Hines and Jones Hall Refresh
ISU Bid #B0028696

12/23/2025

This Addendum issued prior to bidding, alters, amends, corrects or clarifies the Proposal Documents to the extent stated herein and does hereby become a part of the Proposal Documents, and will become a part of the Contract Documents of the successful bidder.

P203

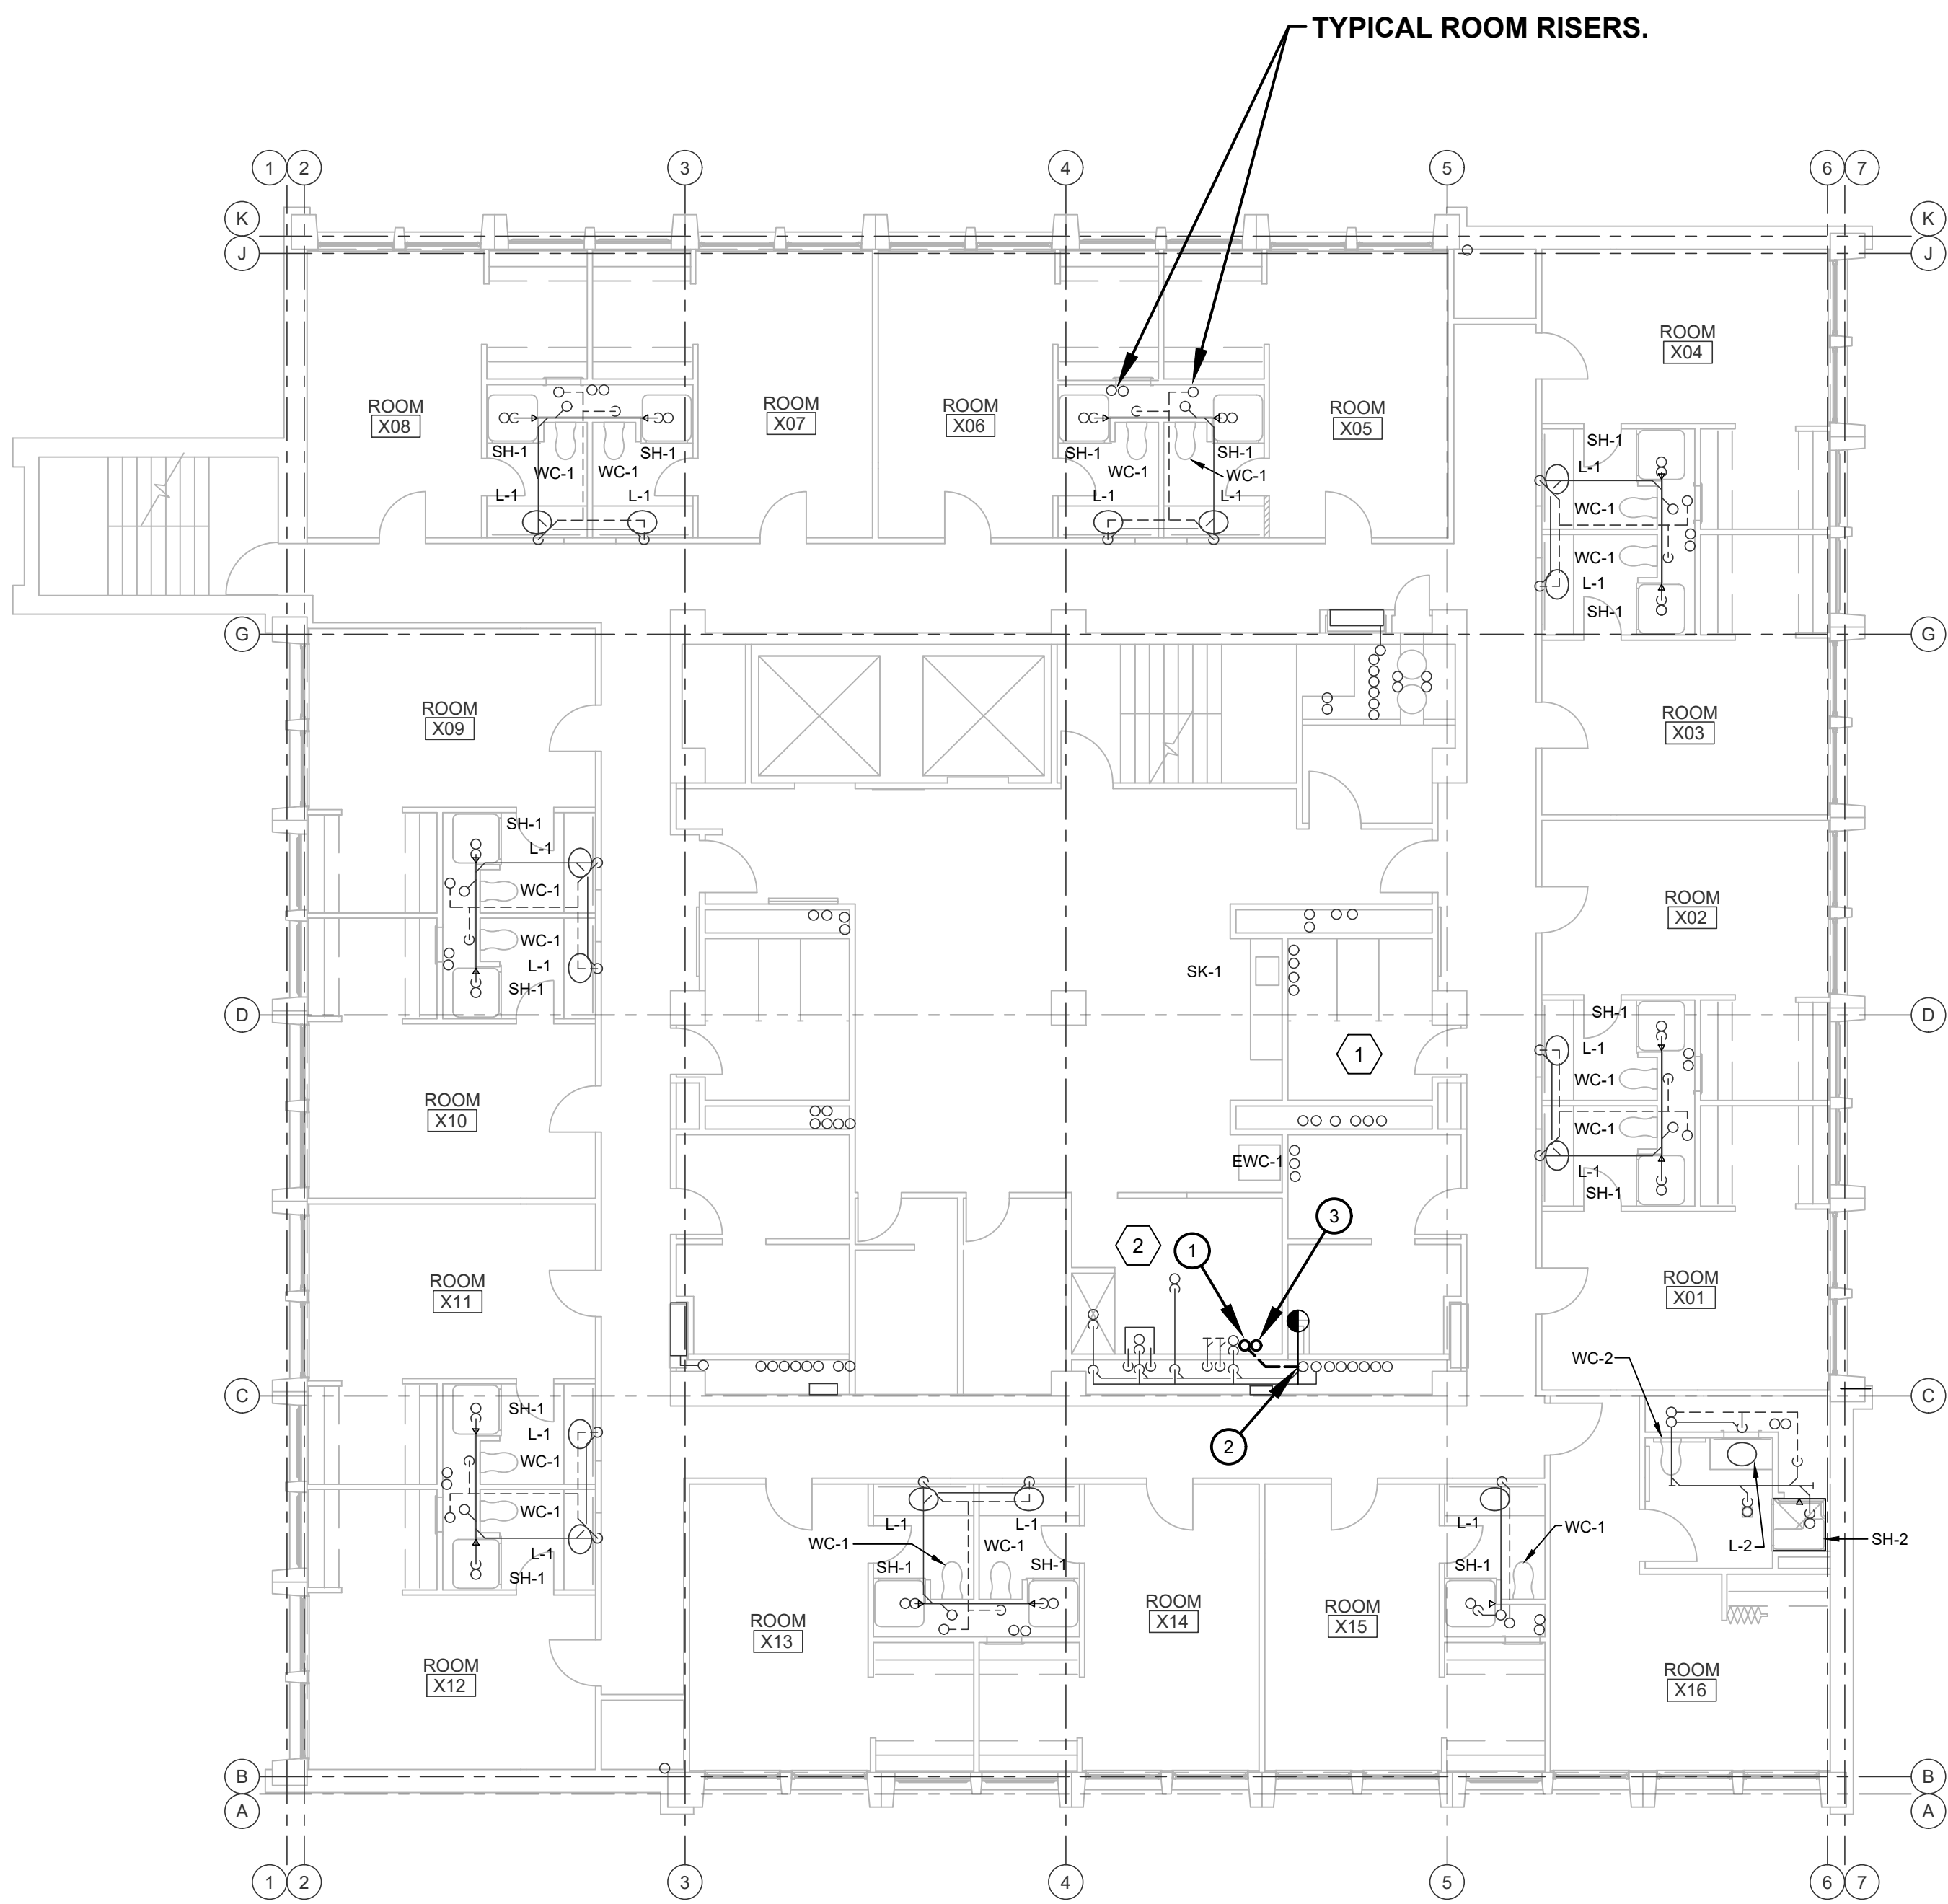
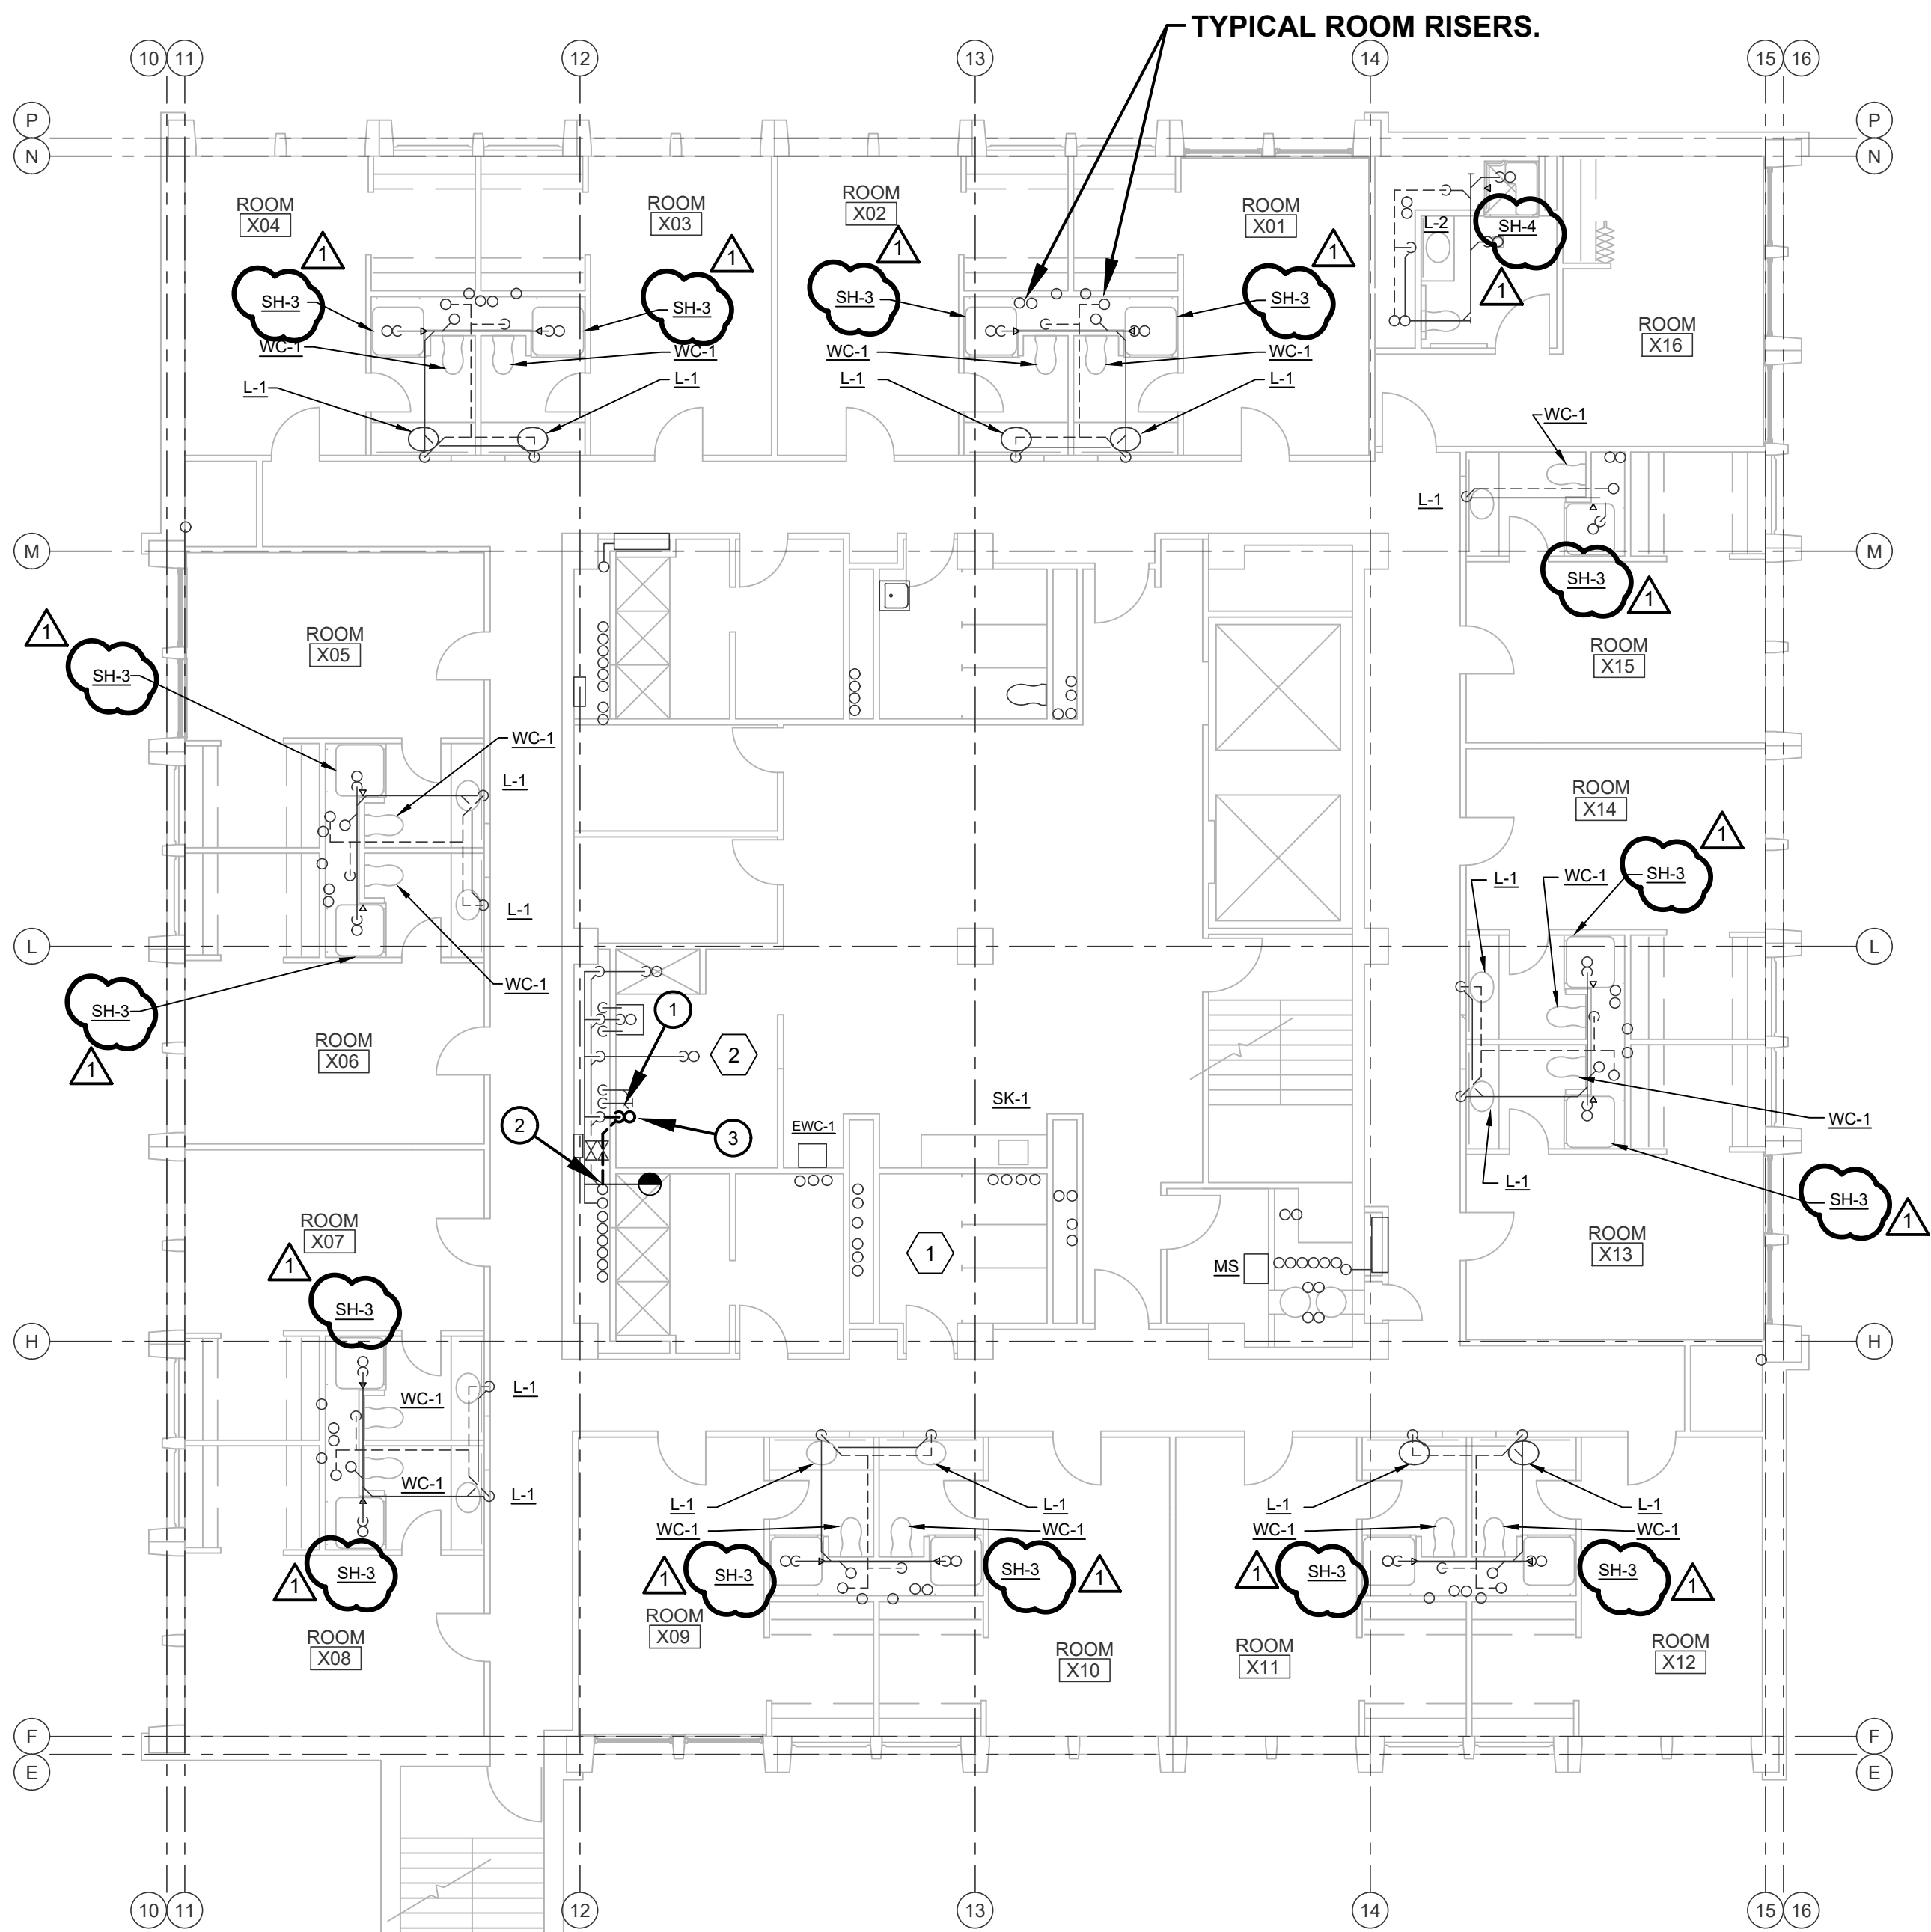
1. Drawing P203 – Second Thru Ninth Floors – Plumbing
 - a. Identifies fixture types and notes riser shutoff valves.

- UNLESS SPECIFICALLY NOTED WITH PLAN NOTE, ALL WORK ON FLOORS 2 THRU 10 IS LIMITED TO WATER CLOSET (WC) FLUSH VALVES, SHOWER (SH) VALVES, AND LAVATORY (LAV) VALVES.
- ALL CORE DRILL HOLES THRU SLAB BY M.C.
- SHUT-OFFS FOR TYPICAL ROOM HW AND CW RISERS ARE LOCATED ON 2ND (LOW PRESSURE) FLOOR AND 7TH (HIGH PRESSURE) FLOOR. EXERCISE ALL RISER SHUT-OFF VALVES. REPORT ANY NON-OPERATIONAL / FROZEN VALVES.
- REFERENCE P621H AND P621J FOR SPECIFIC ROOM DESCRIPTION REQUIREMENTS.
- SEE ALSO PM001.
